# SERVICE BULLETIN

Service Bulletin No.: DA20-25-01 Rev 0

Title: Installation of Rescue Hammer

1. **ATA Code:** 2560
2. **Effectivity:** All DA20-A1 Aircraft.
3. **General:** This Service Bulletin addresses the installation of a Rescue Hammer.
4. **Compliance:** Compliance with this Service Bulletin is optional.
5. **Approval:** Engineering data referenced or contained in this Service Bulletin is approved as part of the type design.
6. **Labor:** Approximately 1.0 hour will be required to accomplish this service bulletin.

**Figure 1**

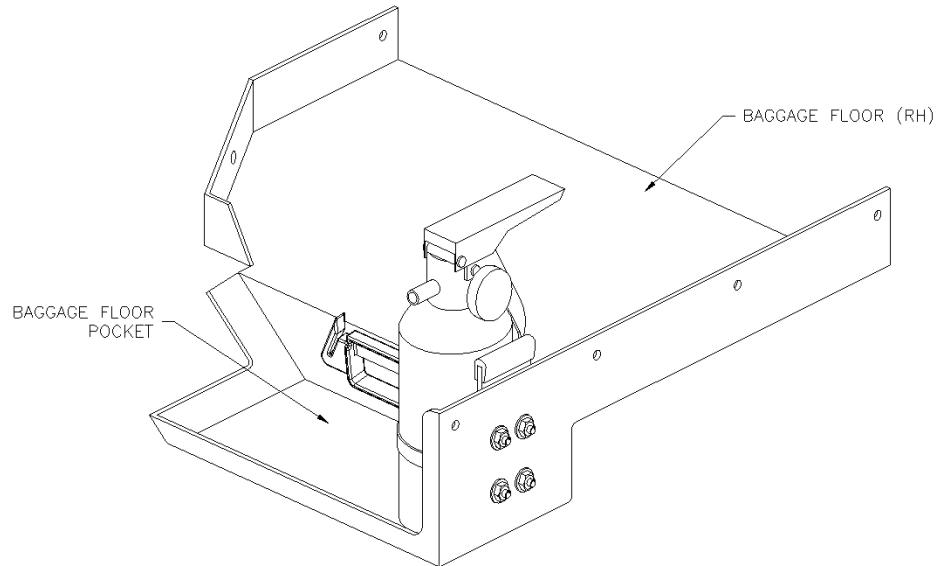
- 10.1 Remove the RH baggage floor as per AMM chapter 25-50-00.
- 10.2 Place the baggage floor on a suitable work table/bench.
- 10.3 Position rescue hammer bracket (p/n 22-2550-63-01) onto the baggage floor (Reference figure 1 and 2):
  - 10.3.1 Measuring from the baggage flange that attaches to the seatback, mark measurement of 155mm AFT.
  - 10.3.2 At the previously marked position, measure 20mm up from the surface of the baggage floor pocket and mark position.
  - 10.3.3 Center the forward bracket attaching hole at the marked location, verify measurements. Position upper edge of bracket parallel to upper surface of baggage floor.

**10.3.4** Hold the rescue hammer bracket securely in place. Using a 1/8 inch drill bit transfer the two attaching holes to the baggage floor.

**10.3.5** Open transferred holes in baggage floor using a #30 drill bit.

**Figure 2**

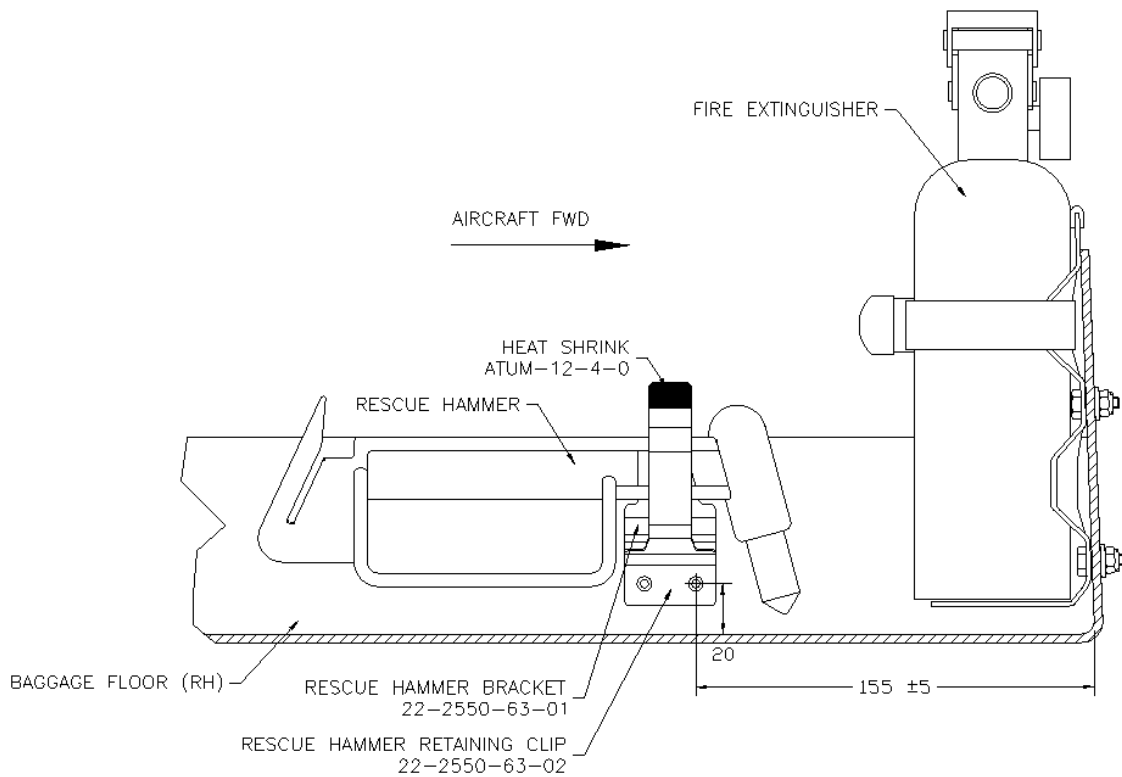
- 10.4 Position the rescue hammer bracket on the baggage floor. Position the rescue hammer retaining clip (p/n 22-2550-63-02) over the bracket as shown in Figure 2. Use Clecos as required.

- 10.5 Attach the rescue hammer bracket and retaining clip to the baggage floor using blind rivets (p/n BSCQ-04-05, rivet head outboard) and plain washers (p/n AN960C4). Position washers on the inboard side of the baggage floor.

- 10.6 Install heat shrink (p/n ATUM-12-4-0) on upper edge of rescue hammer retaining clip as shown in Figure 2.
- 10.7 Install the baggage floor as per AMM chapter 25-50-00. Ensure the installed rivets do not interfere with the fuel tank.

**Figure 3**

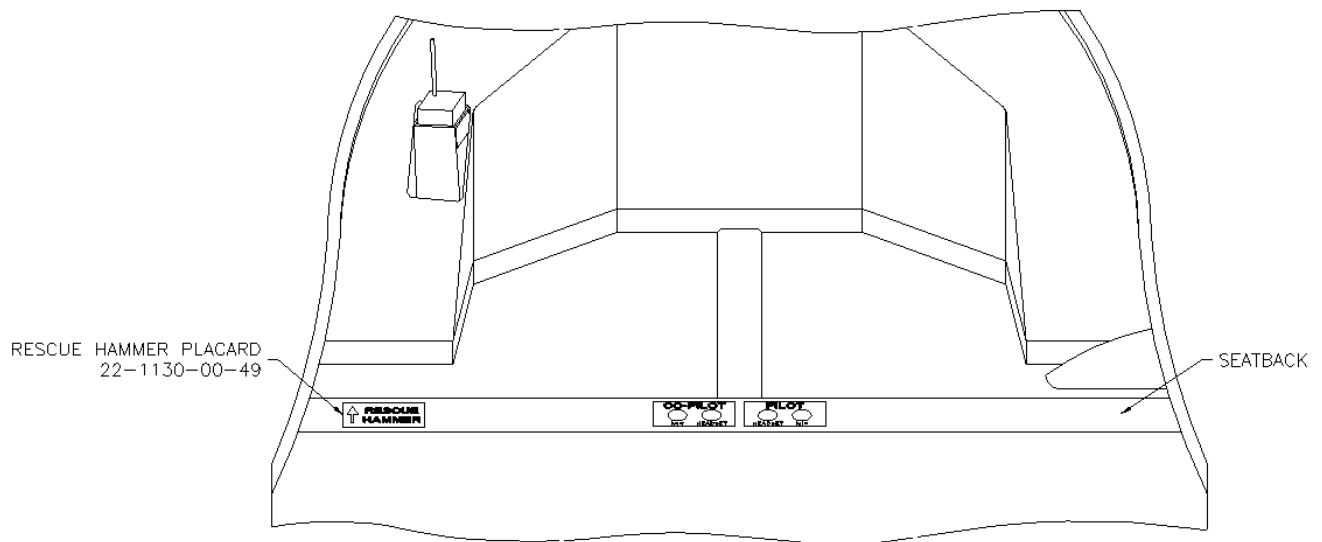
- 10.10 Install rescue hammer placard (p/n 22-1130-00-49) onto seatback as shown in Figure 3. Position placard in between canopy arm pivot and harness attachment.
